1628 Webster Street Addendum 3 – Permit Drawings and Bid Clarifications

The attached drawings are being reviewed by the City of Alameda for building permits as of July 27, 2023.

CONVERSION TO AFFORDABLE HOUSING

POPPY PLACE

MAIN FLOOR PLAN

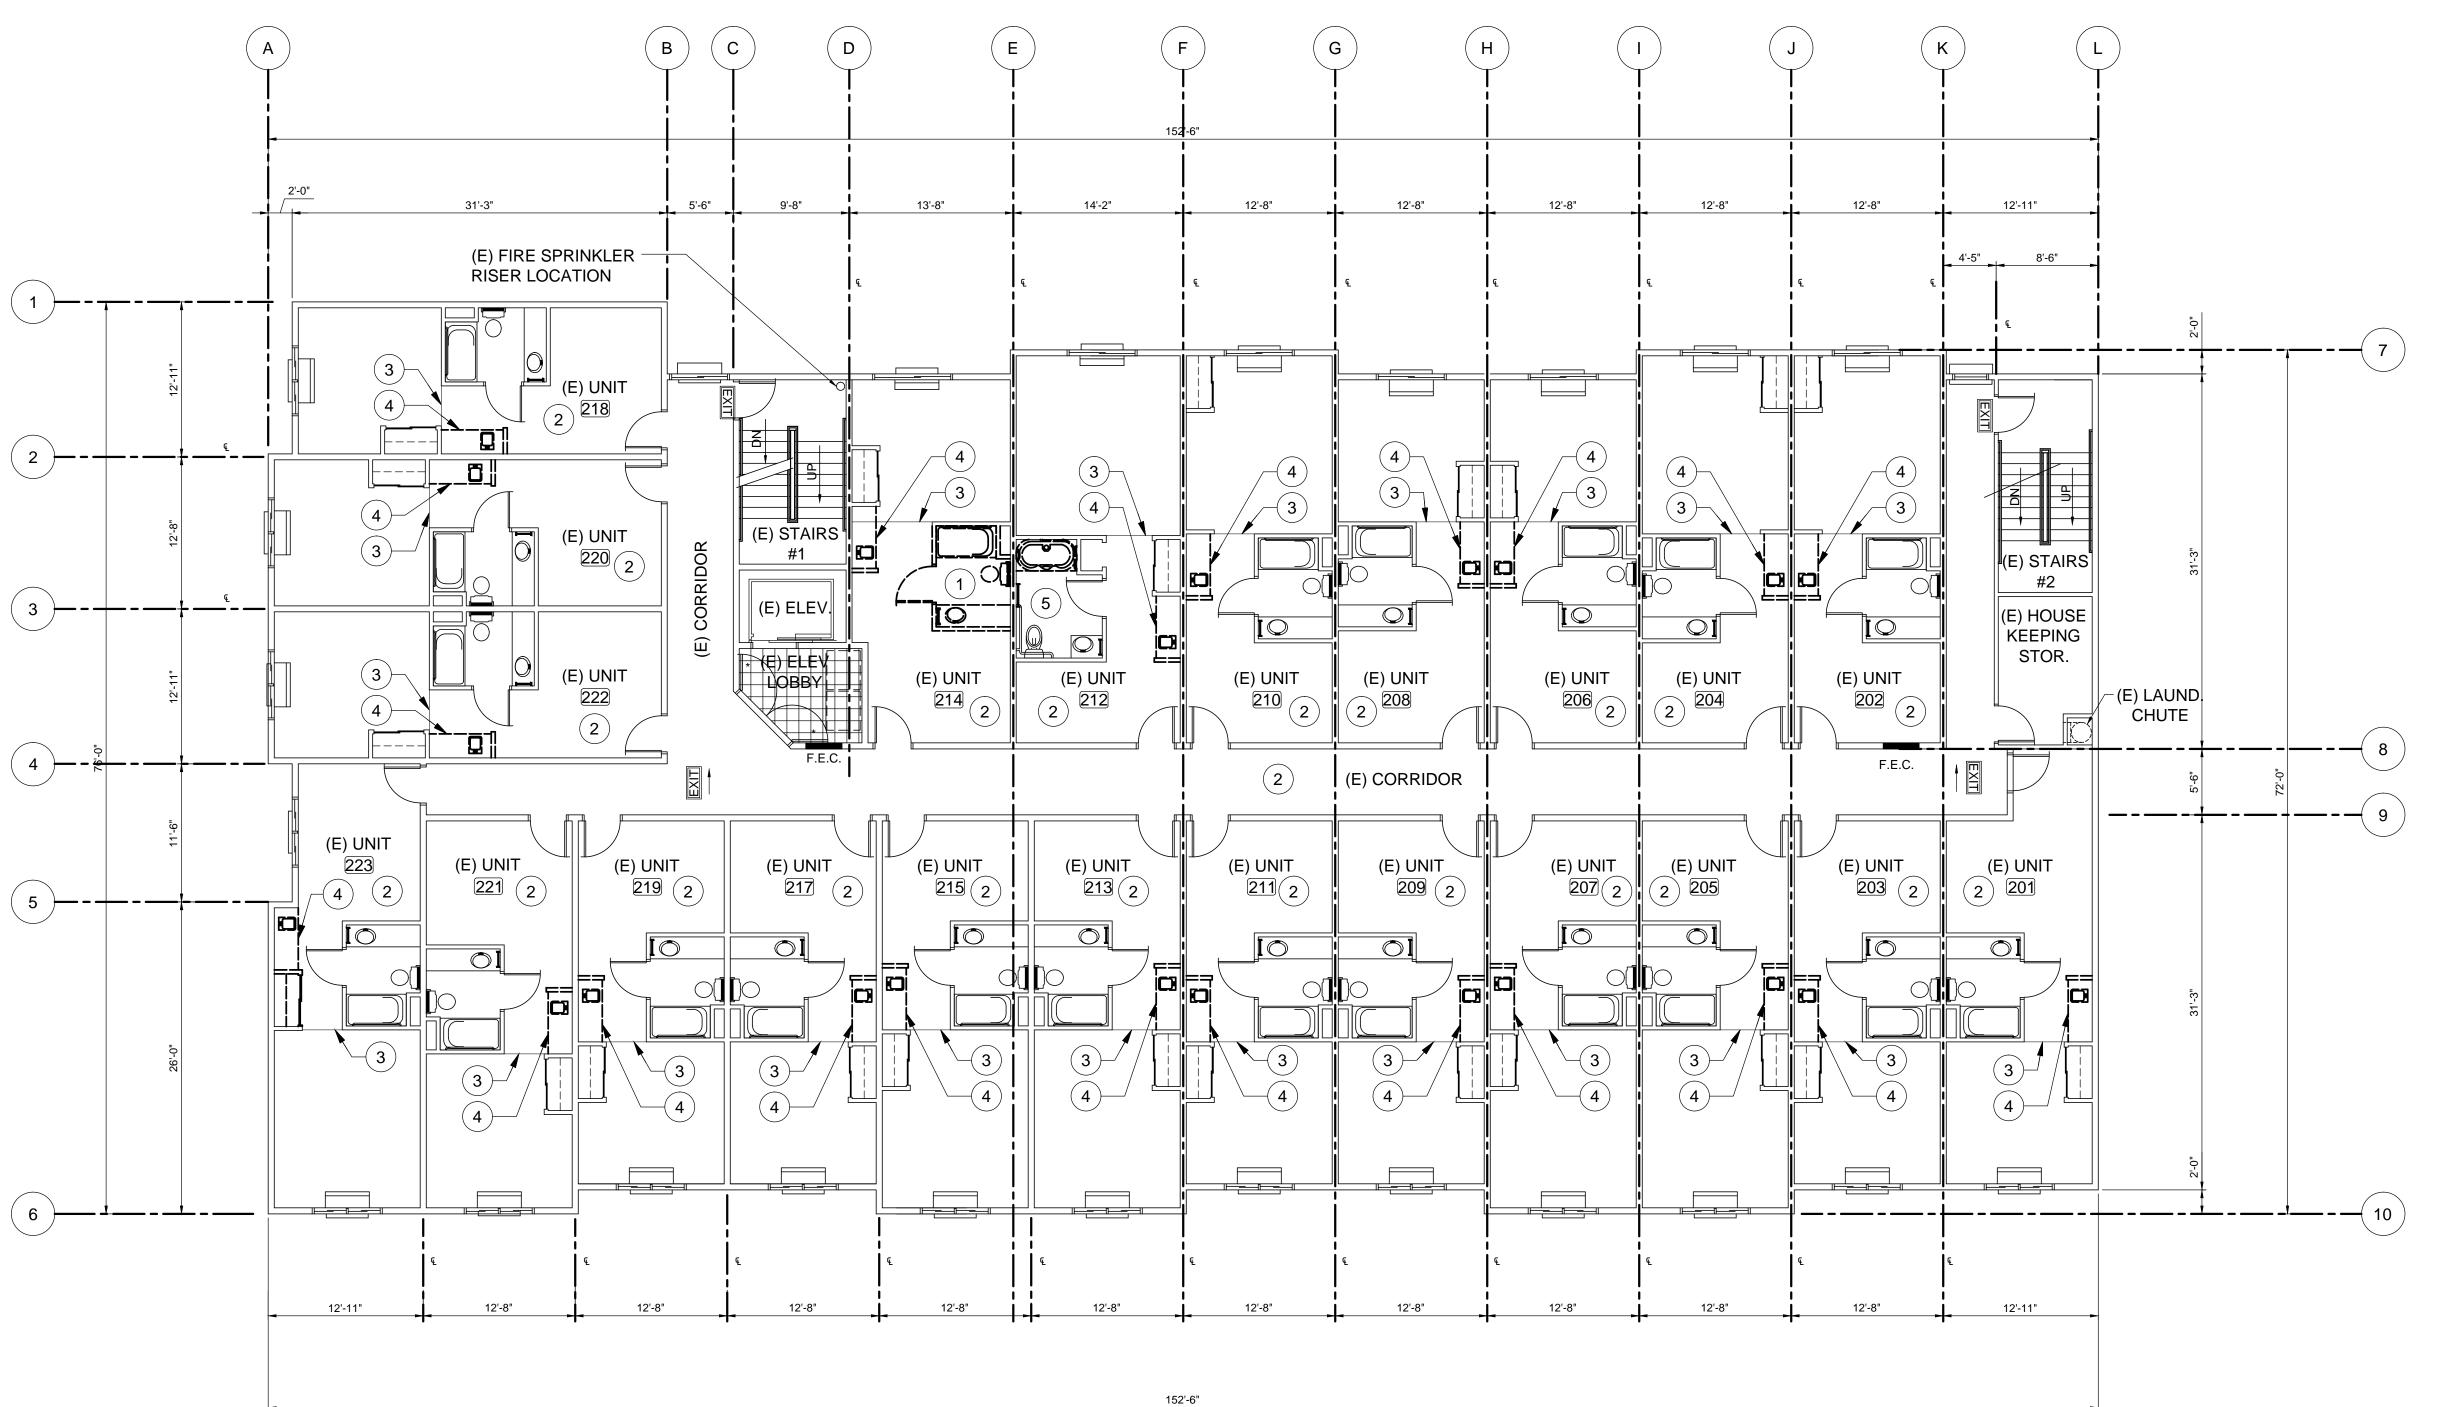
- A. Upper cabinets in kitchenettes.
- B. Demolition of existing laundry chute, per sheet note 9.
- C. Removal of unit headboard units (including attached nightstands), plus associated patching and painting work.
- D. Message board (approx. 8.5x11) at exterior of each unit.
- E. For kitchen hood venting, per stack price to include a stacked vent system, per permit drawings. Unit price for 3 floors stacked and for 2 floors stacked.
- F. LVT flooring in corridors will be required on ground floor, but is an add/alternate for the 2nd and 3rd floors.
- G. Exterior re-painting of entire building.
- H. Additional labor to move/remove furnishings prior to commencing work.

MAIN FLOOR PLAN

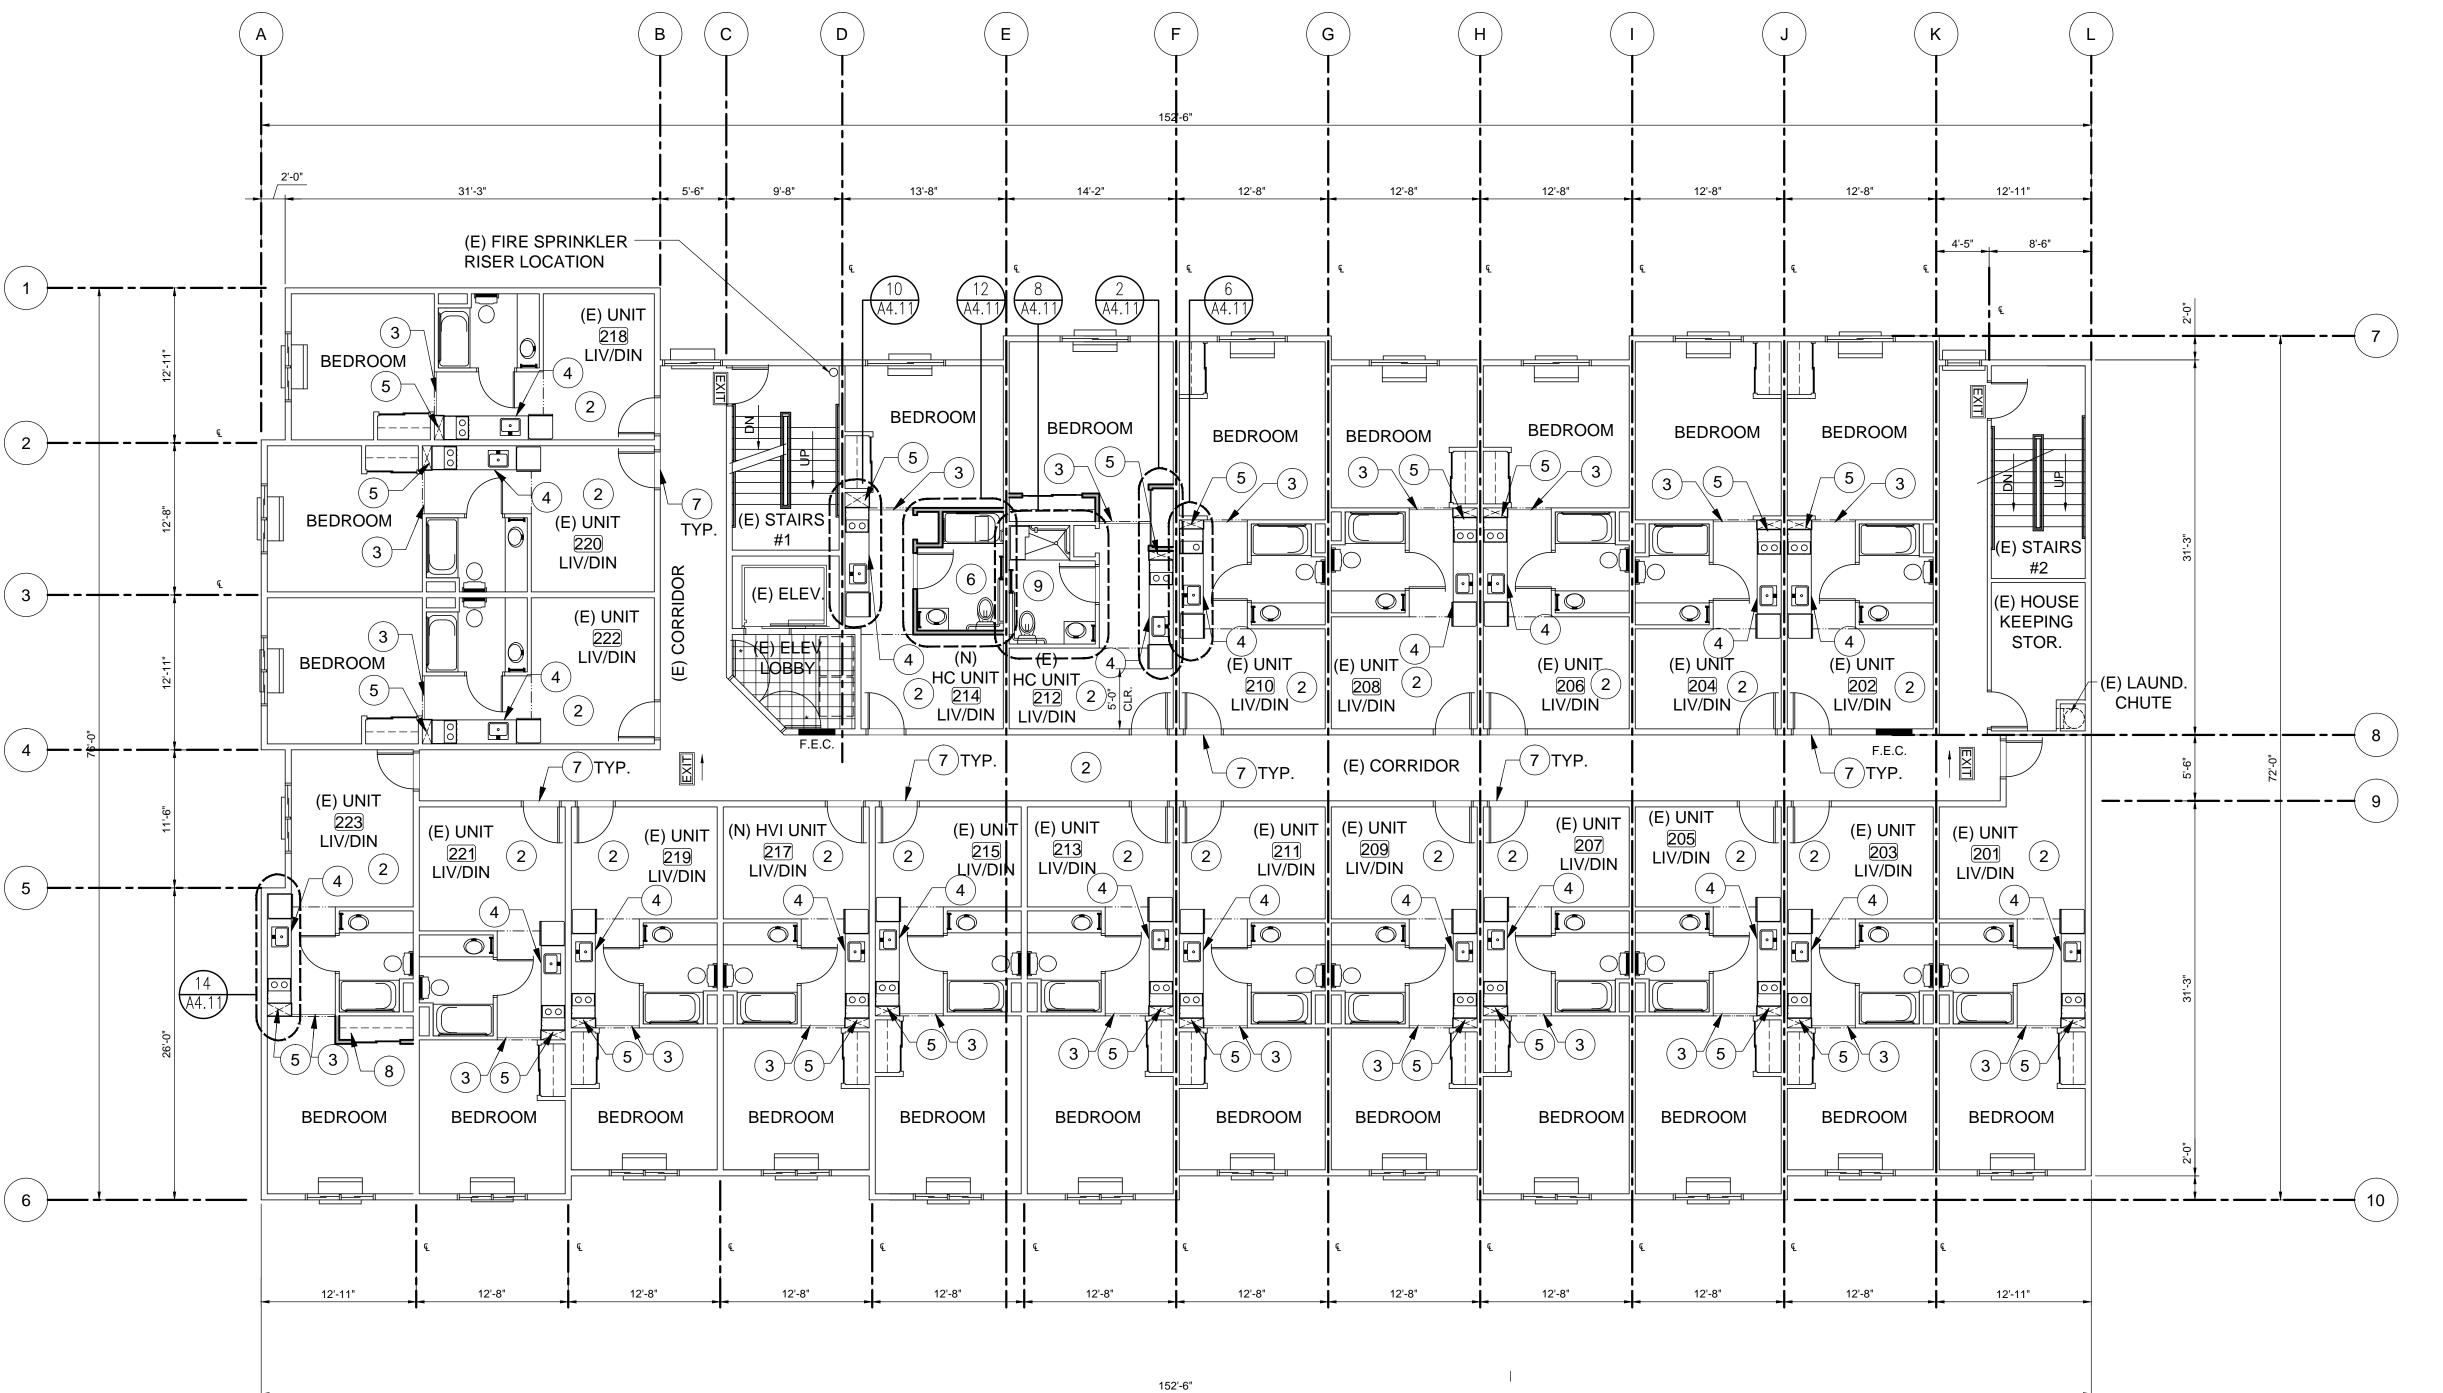
- 9. Existing unit sink and faucet are to be salvaged and reused.
- 10. Despite the permit drawings, the new kitchenette should be priced with a recirculating hood rather than a fully vented system. This is a significant change to the bid set.
- 11. Long term bicycle storage facility is a fully enclosed chain link cage.
- 12. The dog run has been deleted.
- 13. Any fire alarm modifications will be handled as a deferred submittal. The expectation is that only the office area is affected.
- 14. There is a <u>separate RFP for Roof Placement and Solar</u>. Should your firm be interested in this work, you can add the costs and assumptions from that RFP in your bid response for the tenant improvement work.
